Subject: FW: Request for Information Chevrolet Cobalt Ignition Switch P/N

10392423

Engineering Change Support Information Cover Page

GM 3660 approval to implement New PCB and Detent plunger.

741-7937B

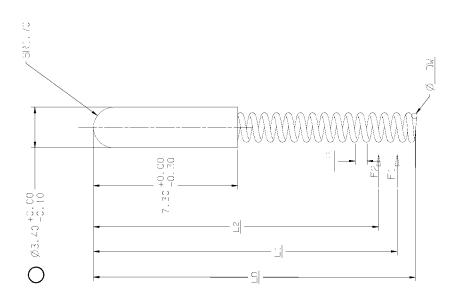
Gary, I think we found what we were looking for. There is a definite difference in length of the plunger and spring between these two versions and it was authorized by the change noted below.

In summary, Engineering Change 57128 authorized, among other things, to change detent spring & plunger assy from p/n 74-175259 to p/n 74-179378 (NME74179378 when released on GES). Looking at the prints of both part numbers they are different and match with the differences described below.

Thank you, but the drawing doesn't explain what the plaintiff (Melton v GM) showed us during deposition. As a reminder, they had the production switch from the subject vehicle (10392423) along with a current service switch with the same part number. The current service part has a longer plunger and a longer spring. These changes are not shown on the drawing you provided.

Main information	This information support the implementation on
about Technical	New PCB 12861211 Rev 5 and the New Detent
Evaluation:	Plunger 741-79378.
	Durability 3 times life test was perform according
	GM specification in Lab Test # C005-177.
	Torque and Angle test was perform in DG with
	Work Request 06-0871
	Ray DeGiorgio (GM RDE) agree to implement
	change without changing GM p/n. He provides his
	approval with GM3660 to implement both
	changes.
	*PCB price is increasing and being in negotiations
	with Viasystems to get a better price, according
	Managers and PDT meeting we can not wait to
	get the correct price because the big fall-out
	registered in the production line closed to 30%
